# Technical Appendix 2.2: TLI Technical Note 1

# TECHNICAL NOTE 1

Project: Barnesmore Windfarm Repowering – 110kV Grid Connection	Ref: Rev2
Section: 110kV Grid Connection Works Review	Job No: 05-728
	Date: 13.12.19
Made By: SK	Checked By: RG
	Sheet No: 1 of 6

<b>Technical Lead:</b>	Shane Kiely - TLI Group
<b>Date of Writing:</b>	13.12.19
<b>Scope of Note:</b>	Review of the 110kV Grid Connection and associated works for the Barnesmore Windfarm Repowering
<b>Documents &amp; Data Issued for Review:</b>	TLI-05728-GC-DR-F-001-00 Cable Interface Tower Details TLI-05728-SS-DR-F-001-03 Proposed Golagh SS Layout Plan PE687-D318-005-004-000 Cathaleen’s Fall – Golagh Tee 110kV Line Route

**Figure 1 - Clogher SS/Golagh Tee Connection Point**

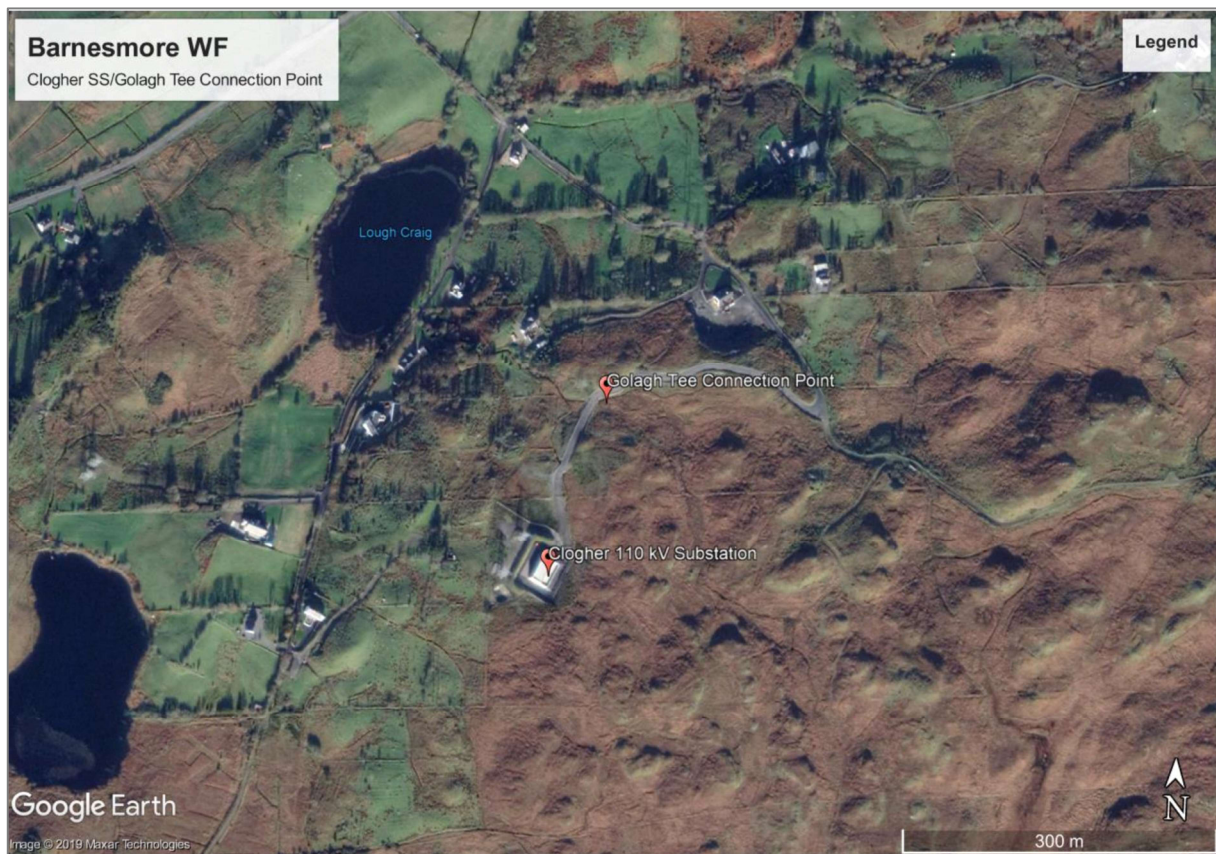
- Construction of a new Cable Interface Tower between Structure 130T and Structure 310
  - New cable interface tower to be built on the east side of the Cathaleen’s Fall-Letterkenny 110kV OHL, under the existing Golagh Tee 110kV OHL
- Underground Cable connection from new interface tower to Clogher 110kV GIS Substation (Spare Bay)

- Removal of hard tee-connection between Cathaleen's Fall-Letterkenny 110kV OHL and Cathaleen's Fall-Golagh Tee 110kV OHL.
- Retirement of existing structure 130T
- Termination of existing conductor to new proposed cable interface tower

Figure 3 - Golagh 110kV Substation

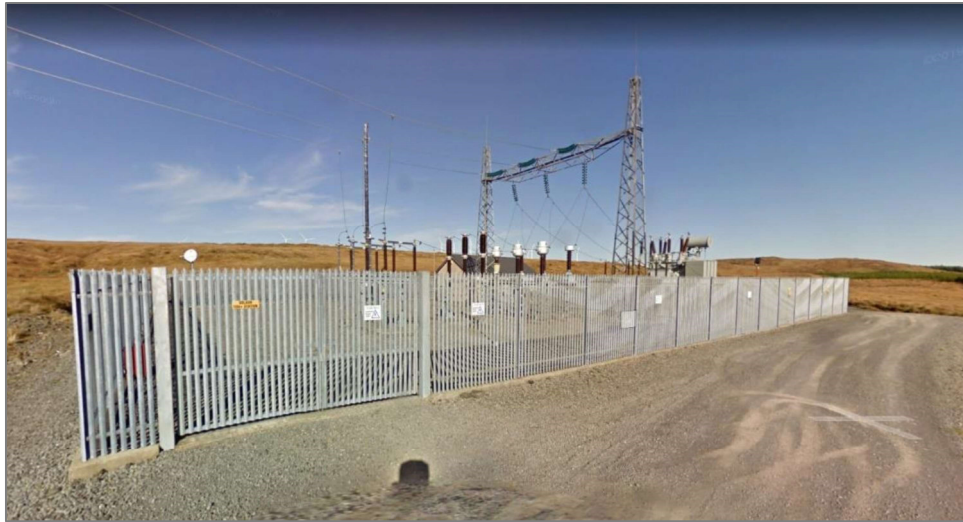
- Extension of the existing substation compound to the west, north and east
- Installation of a new substation access point on the west side of the substation

- Installation of a second substation access point on the east side of the substation
- Installation of a new substation boundary and perimeter fence
- Construction of a new EirGrid control building as per new specification

- Extension of the existing control building to be used as the IPP control building
- Installation of a larger transformer (incl. transformer bund and plinth)

- Installation of a new Auxiliary Transformer
- Installation of reactive compensation equipment (if required)
- Retirement of the exiting OHL connection
- Installation of a 110kV Cable Chair

- Connection of a new 110kV UGC to the new cable chair
- *Surge arresters at line side are currently located on line disconnect. TBC with EirGrid.*
- *Maintaining use of gantry for over the fence connection. TBC with EirGrid.*

- *Location of transformer disconnect and surge arresters to remain in IPP side of substation. TBC with EirGrid.*

Figure 4 - Golagh 110kV Substation – Existing Layout

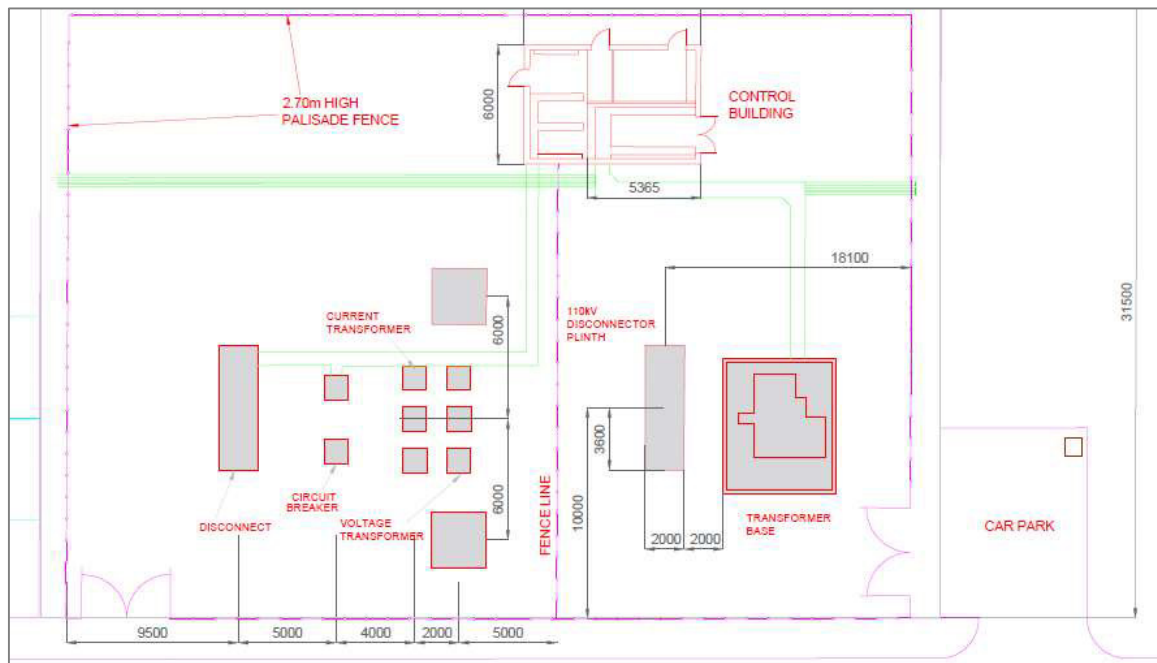
A review of the existing substation design and a comparison to the new EirGrid Specification to identify how the existing substation could be upgraded and expanded to meet the new EirGrid requirements rather than constructing a new substation. The main difference between the existing substation layout and the new EirGrid specification is the requirement for a larger EirGrid control building. The Consultant is proposing that the existing substation compound is extended to the west to facilitate the construction of a new EirGrid control building.

The Consultant is also proposing that the substation compound be extended slightly to the east to facilitate the installation of the larger transformer required for the windfarm. The compound will also need to be extended slightly to the north to facilitate the larger IPP building and Aux Transformer. The Consultant is proposing to maintain the current layout of the 110kV switchgear where possible, however this will need to be confirmed with EirGrid as the current layout varies in some areas to the new specification. It should be noted that some of the 110kV switchgear may need to be upgraded to a higher rating as part of the project works. The proposed 110kV grid connection reconfiguration works and substation expansion works are subject to detailed design.
